In re: K228FC, Lost Creek, TX
BMPFT-20160129AYC
Facility ID No. 138173

This refers to the above-captioned minor change application for K228FC.

Overlap attachment:

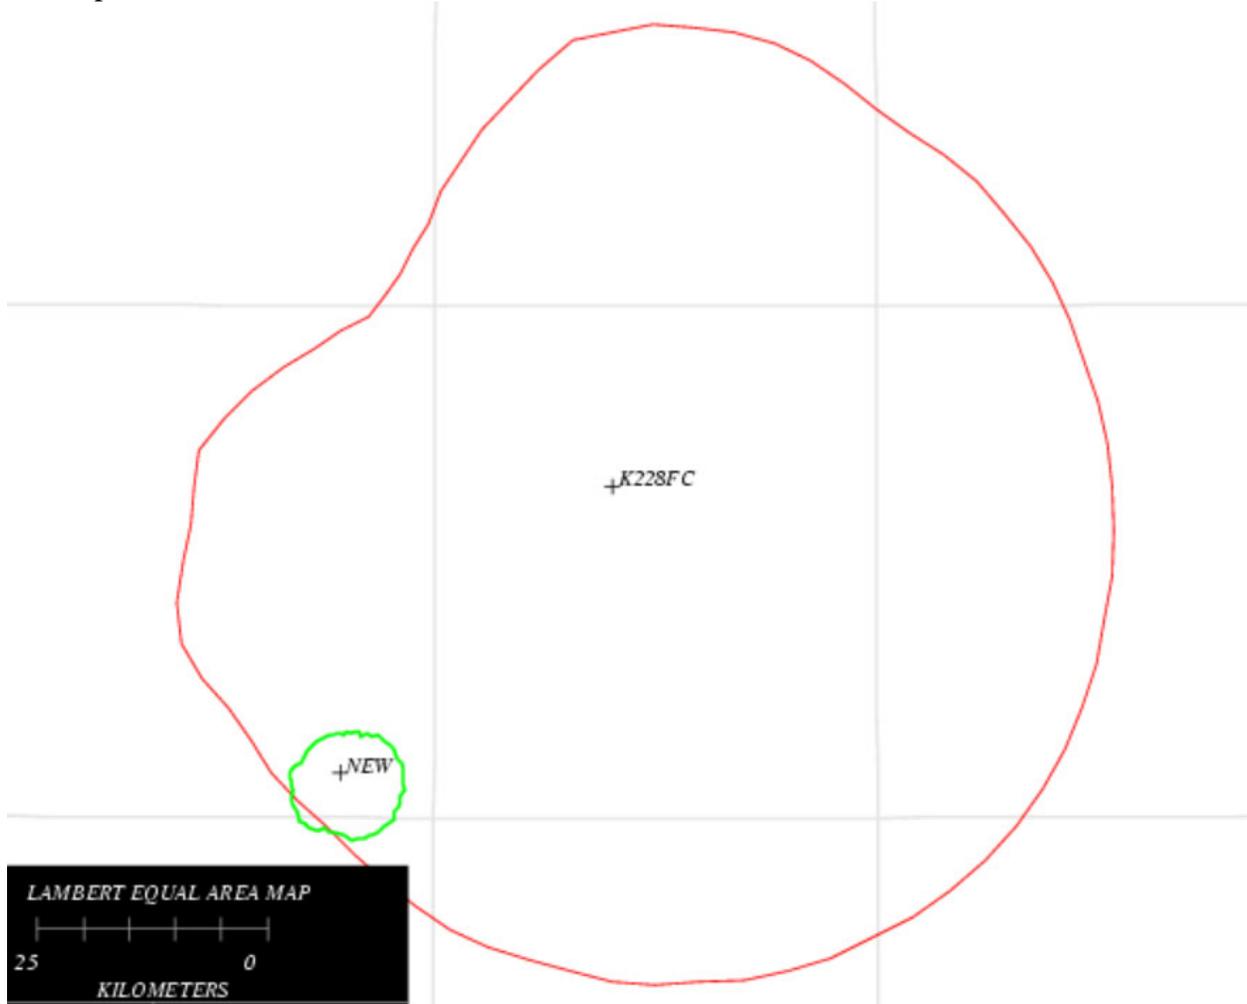
An engineering study reveals the application is in violation of the interference protection requirements of 47 C.F.R. Section 74.1204. Specifically, the proposed 40 dBu interfering contour overlaps the 60 dBu protected contour of the facilities of a co-channel LPFM construction permit for a new station in Wimberley, Texas (BNPL-20131114AVE). The application does not recognize this defect. Accordingly, we dismiss the application as unacceptable for filing.

Red contour: K228FC BMPFT-20160129AYC – 40 dBu interfering contour

Green contour: New-LP, Wimberley, TX BNPL-20131114AVE – 60 dBu protected contour

In light of the above, application BMPFT-20160129AYC is unacceptable for filing pursuant to 47 C.F.R. § 73.3566(a) and IS HEREBY DISMISSED. This action is taken pursuant to 47 C.F.R. § 0.283.
